1 Rosemead Road, Hornsby

Heritage Peer Review

Report prepared for NSW Department of Planning, Industry and Environment

October 2020

Figure 3.2 Detail of the site plan for the proposal. (Source: Armada)

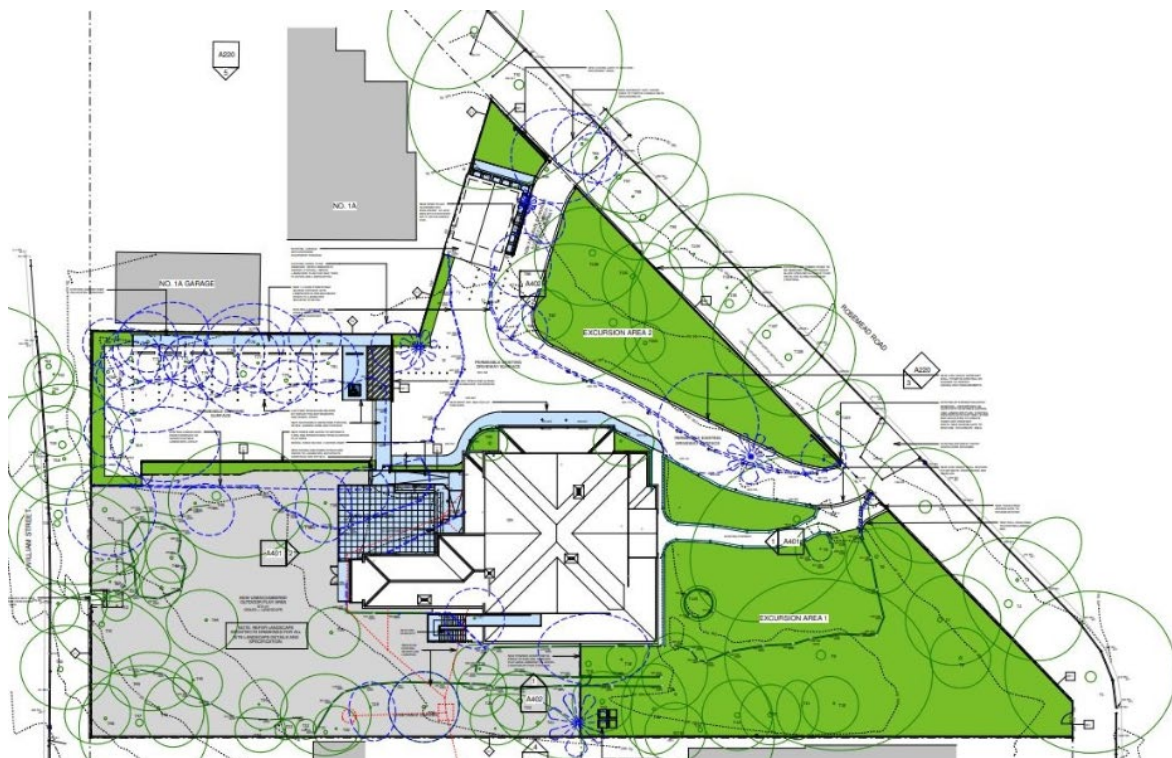
| Proposed Works Item | Council Submission | Review of Council Submission |
|--|--|---|
| 3. New Driveway Exit onto Rosemead Rd. | <p>Impact: Unsympathetic</p> <p>Concerns were raised about the new driveway placement due to the removal of 10 contributory trees and the impact on landscape aesthetics, and the site's contribution to the streetscape.</p> <p>Recommendations:</p> <ul style="list-style-type: none"> Alternative solution investigated to provide the second driveway off William Street to minimise the impact of significant trees on site. A revised heritage impact assessment and justification for the alternative design. | <ul style="list-style-type: none"> The trees proposed for removal are of moderate and low significance. The potential heritage impact would be minor. The retention of trees of high significance in the immediate vicinity will ensure the character of the garden remains intact. The removal of the trees would have a negligible impact on the HCA. Trees T95 and T96 are located outside of the property boundary and form part of local heritage item 544, 'Street Trees'. They are assessed as having low significance in the AIAR. No other trees within item 544 will be impacted by the proposed driveway exit. The impact on item 544 would be minor. |

| Community Submissions—Heritage Related Issues | Discussion and Assessment |
|---|---|
| Alteration of the driveway | <ul style="list-style-type: none"> Several submissions objected to the widening of the driveway on the grounds of the disruption of the garden, the change in the presentation of the house, the removal of tree plantings, the loss of heritage fabric and the change in the character of the property. It is recommended that the driveway design be amended to avoid the removal of trees T111 and T112, which are of very high landscape significance. Recommendations to minimise visual impacts on Mt Errington and the HCA are also proposed in response to this concern. |

- However, there are some aspects of the proposal that require amendment in order to reduce the heritage impacts.
 - The driveway realignment should be revised in order to retain the front gates and highly significant trees.

- **Carparking and drop-off:** the provision of a drop-off area and carparking on the site involves the removal of original landscape features and significant trees and will have a high impact on the setting and significance of the place. Alternative designs and landscape plans should be developed that investigate off-site carparking and drop-off/pick-up zones. On-site parking should be minimised to reduce heritage impacts on the setting, landscape character and significance of the site.

- An amended Landscape Plan should be submitted which reflects the changes recommended above, including the amended driveway solution and parking designs with the retention of the tennis court, original gates and posts, and trees T111 and T112 in situ.

Figure 3.4 First floor plan showing the proposed works. (Source: Armada)

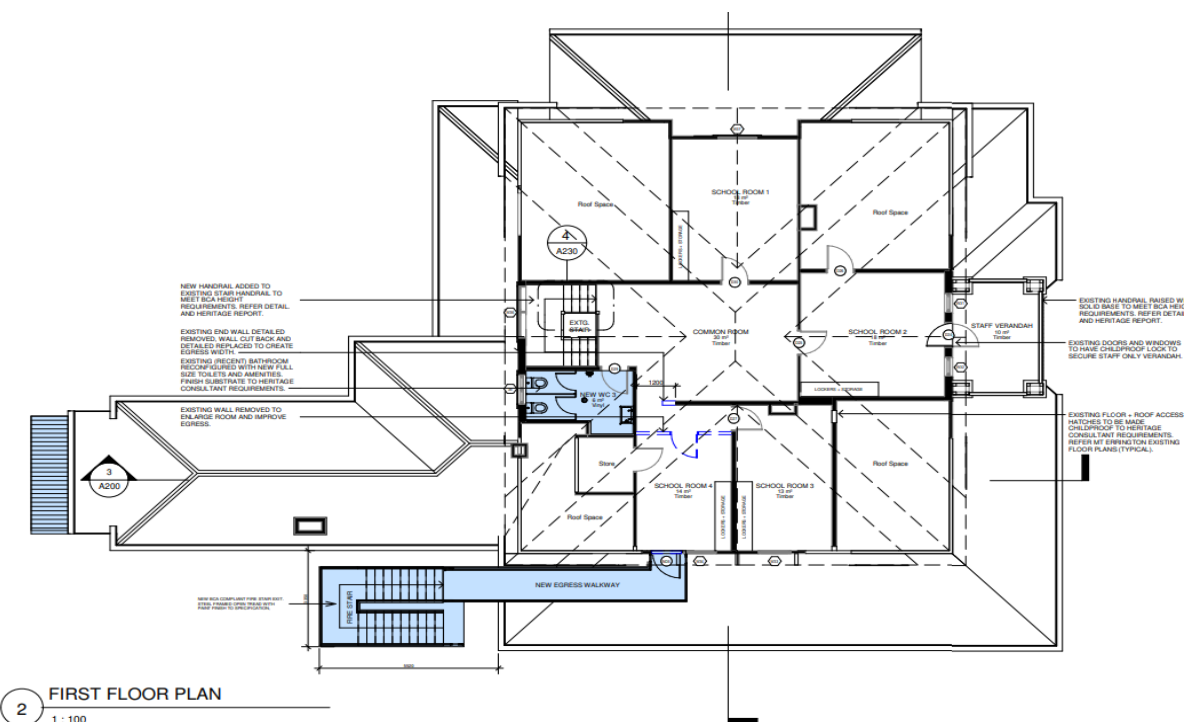
| Proposed Works Item | Council Submission | Review of Council Submission |
|--|---|--|
| 29. School Room 4 and Common Room existing wall removed | <p>Impact: Minor</p> <p>No objections are raised to the removal of the wall. It is a negligible modification located in a less important area and would not adversely affect the heritage significance of the place. Nibs of the original wall should be retained to permit interpretation of the original floor plan. Amended plans should be submitted to reflect the requested change.</p> <p>Recommendations:</p> <ul style="list-style-type: none"> Retention of wall nibs. | <ul style="list-style-type: none"> We concur with Council's assessment and recommendations. The proposed removal of the wall would have a minor heritage impact. Wall nibs should be retained to interpret the existing layout. |

- **Removal of the wall in Room 4:** the removal of the wall in Schoolroom 4 should include the retention of wall nibs to interpret the demolished wall/original floor plan and this should be noted on the drawings.

Figure 3.5 Detail of the proposed works to the southern elevation. (Source: Armada)

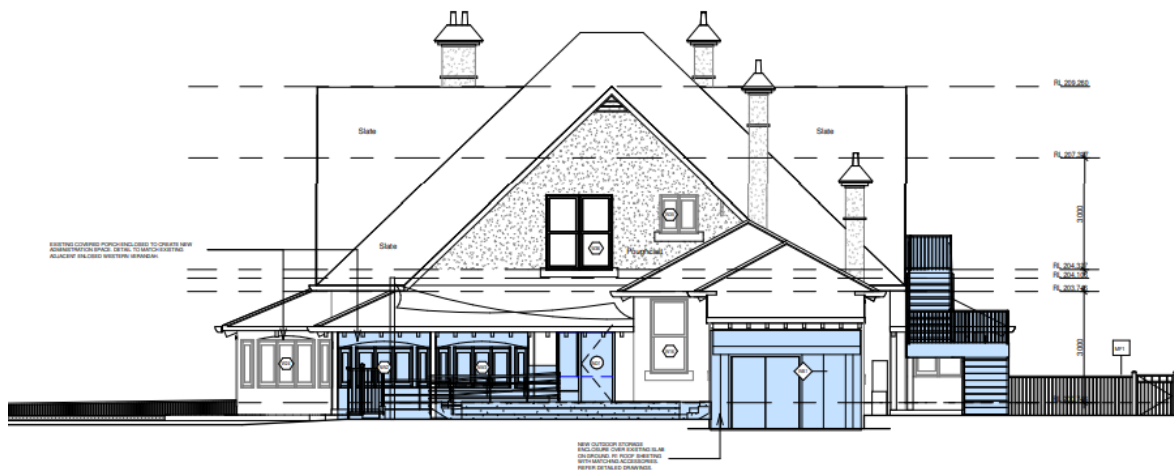
| Proposed Works Item | Council Submission | Review of Council Submission |
|--|---|--|
| 9. New BCA compliant external fire stair | <p>Impact: Adverse</p> <p>Council recognises the need for a fire stair to meet BCA requirements and accepts the adverse impact it will have on the heritage significance of the place, its visual setting and views to and from the site.</p> <p>Concern is raised over the proposed colour scheme of the stair.</p> <p>A detailed drawing of the new fire egress door (ND5) should be included on the Architectural Plans (East Elevation) to meet the heritage requirements, and designed to complement the heritage item in design and materials.</p> <p>Recommendations:</p> <ul style="list-style-type: none"> The paint finish should match the existing exterior colour scheme of the house to minimise the visual impact, complement the heritage item and meet heritage and regulatory requirements. Architectural detail illustrating the new design of ND5 to meet heritage and regulatory requirements. | <ul style="list-style-type: none"> It is noted that a second exit from the upper floor is required due to the use of the building as a school. The heritage impact would be moderate, based on the following: <ul style="list-style-type: none"> The proposed fire stair is an unsympathetic addition that sits awkwardly with the existing form of the building. Although the stair will be visible from Rosemead Road, it will not be visually prominent as it located towards the rear of the house and will be substantially screened by vegetation. The stair will be designed to be removable in the future. There will be little impact on the (largely intact) interior spaces of the house. To reduce the impact of the stair it is recommended that: <ul style="list-style-type: none"> Alternative locations and/or designs for the stair be considered in order to minimise impacts. Paint colours for the stair should be sympathetic to the house but also recessive (ie dark in tone). Should the stair remain in its current location the window into School Room 3 should be altered to be a doorway rather than forming a new separate doorway. The window should be salvaged and stored safely on site for potential reinstatement in the future. The existing opening should not be widened or increased in height when forming the doorway. |

| Community Submissions—Heritage Related Issues | Discussion and Assessment |
|---|---|
| External stair | <ul style="list-style-type: none"> Several submissions objected to the design of the proposed external stair. These objections primarily relate to the bulk, design and materiality of the addition which would be visible from the street. The stair is required as part of the change of use. The stair will not be visually prominent from Rosemead Road, but it does represent an unsympathetic addition. It is recommended that alternative locations for the external stair be considered to reduce impact. |

- **External stair:** the proposed external stair would have a moderate adverse heritage impact. Alternative designs/locations for the stair should be considered in order to find a solution with reduced heritage impact. If alternative locations are not available, the design should be revised to omit the new doorway and instead adapt an existing window to form a doorway. Details of the new door and stair should be submitted for approval, including proposed paint colours which should be sympathetic to the house but also recessive. The stair should be reversible and able to be removed in the future without undue damage to the fabric of the house.
